**TRANSMITTAL OF THE RESPONSE TO OHIO ENVIRONMENTAL PROTECTION
AGENCY COMMENT ON ADDENDUM 1 TO THE CERTIFICATION DESIGN
LETTER AND CERTIFICATION PROJECT SPECIFIC PLAN FOR AREA 6 FORMER
PRODUCTION AREA AND MAIN DRAINAGE CORRIDOR AREA FOR THE
CERTIFICATION OF THE FORMER SOIL PILE-8 AREA**

**FERNALD CLOSURE PROJECT
FERNALD, OHIO**

**RESPONSE TO THE OHIO ENVIRONMENTAL PROTECTION AGENCY COMMENT
ON ADDENDUM 1 TO THE CERTIFICATION DESIGN LETTER AND
CERTIFICATION PROJECT SPECIFIC PLAN FOR
AREA 6 FORMER PRODUCTION AREA AND MAIN DRAINAGE CORRIDOR AREA
FOR THE CERTIFICATION OF THE FORMER SOIL PILE-8 AREA
(20810-PSP-0010, Revision 0, Addendum 1)**

Figure A-8 Soil Pile 8 Area - Phase 3 Moisture Corrected Radium-226

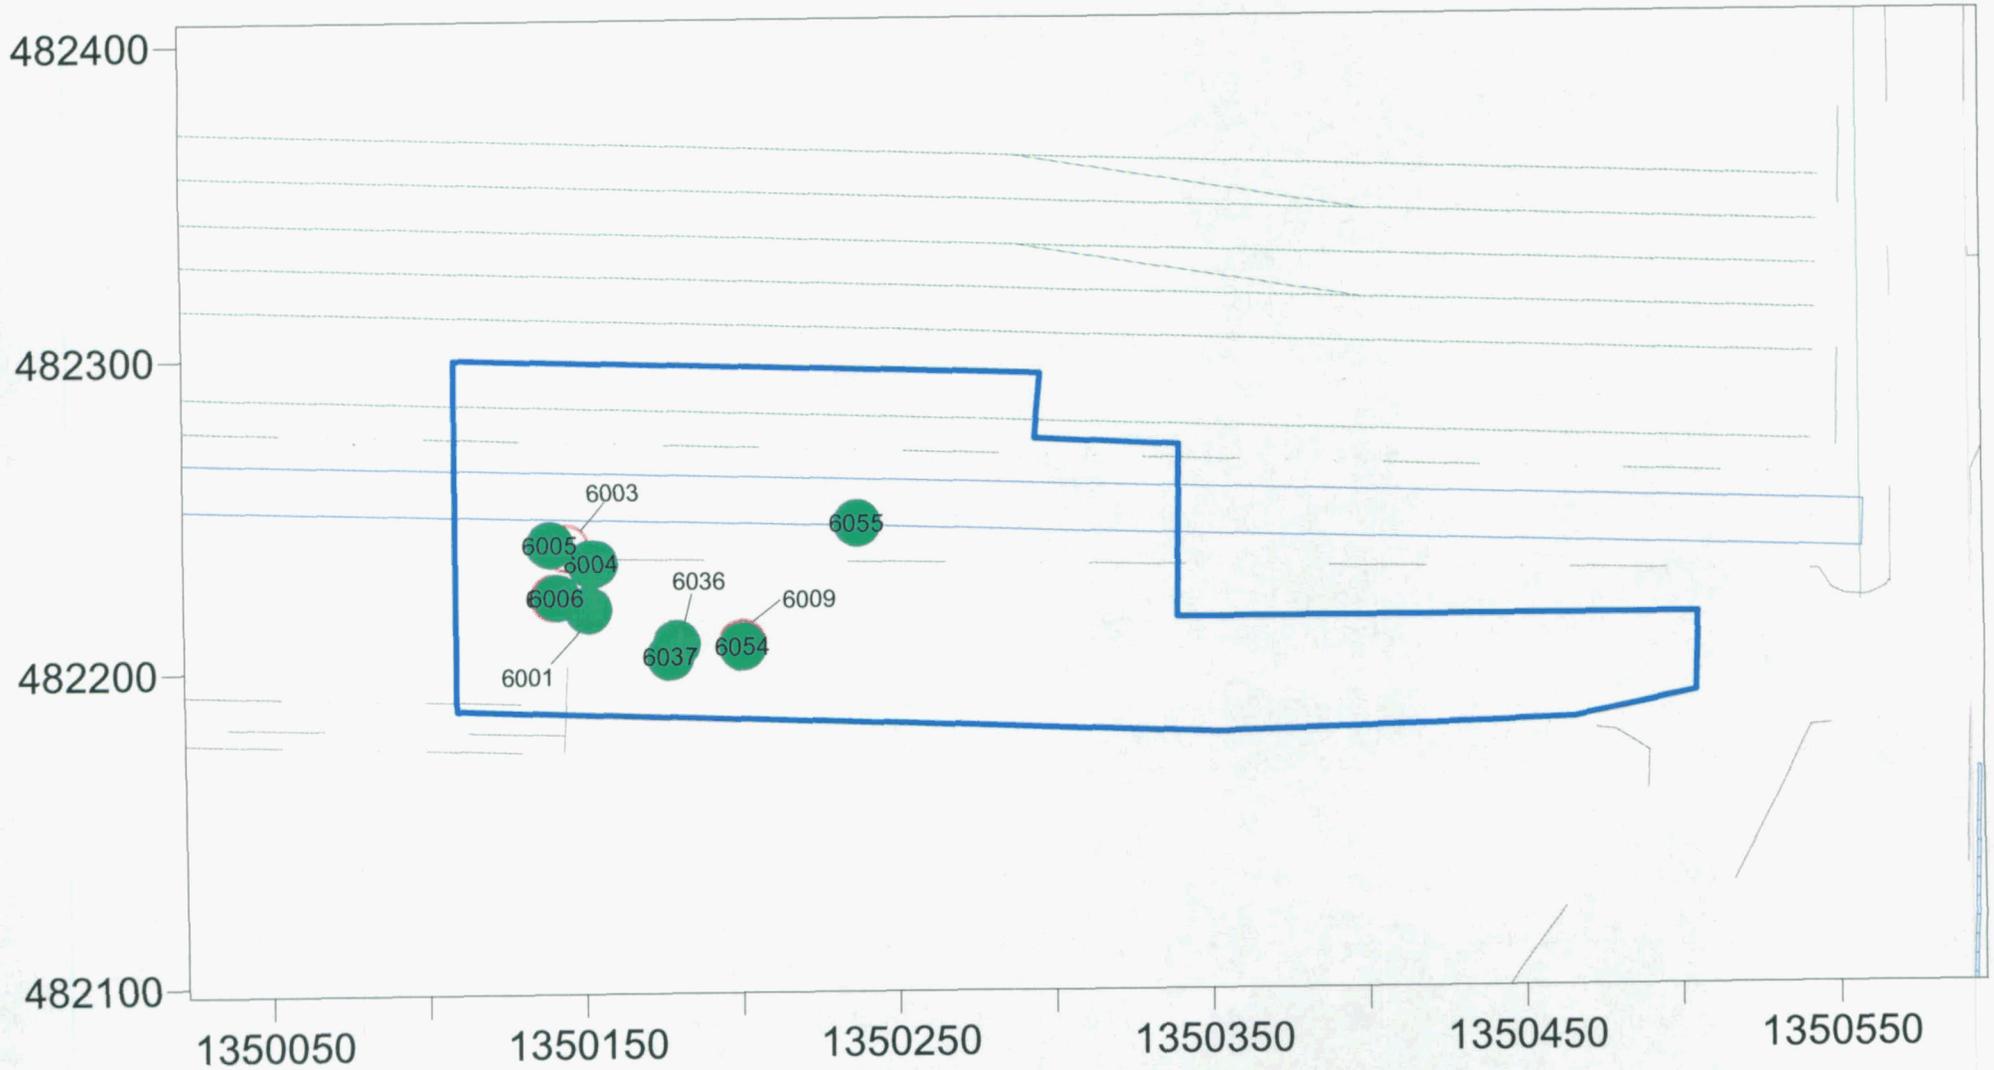
Comment: The text states that "above-FRL radium 226 conditions were found" several times during precertification, and that additional excavation took place until the real-time scans showed conditions passed. However, the text does not correspond with the data on Figure A-8, which shows that Ra-226 still remains. Please provide clarification in the text and include the real-time data showing that the Ra-226 has been removed.

Response: Figure A-8 (Phase 3 real-time measurements) shows several HPGe measurement results in the same general location that are overlaid on each other. These measurements were taken in succession after each excavation until the HPGE measurements indicated radium-226 results <3*FRL. Although the data on Figure A-8 is plotted chronologically (to show the passing result on top), this is not readily apparent on the map due to the hotspot results (in red) beneath the final clean result (in green) and the use of thin-line circles. The map has been revised to show the final clean radium-226 results as solid green circles to clearly illustrate that the radium-226 hotspots were excavated.

The text in Section 2.2.1 is correct and no revision is necessary.

Action: Figure A-8 (enclosed) was revised to clearly indicate that final radium-226 results were <3*FRL.
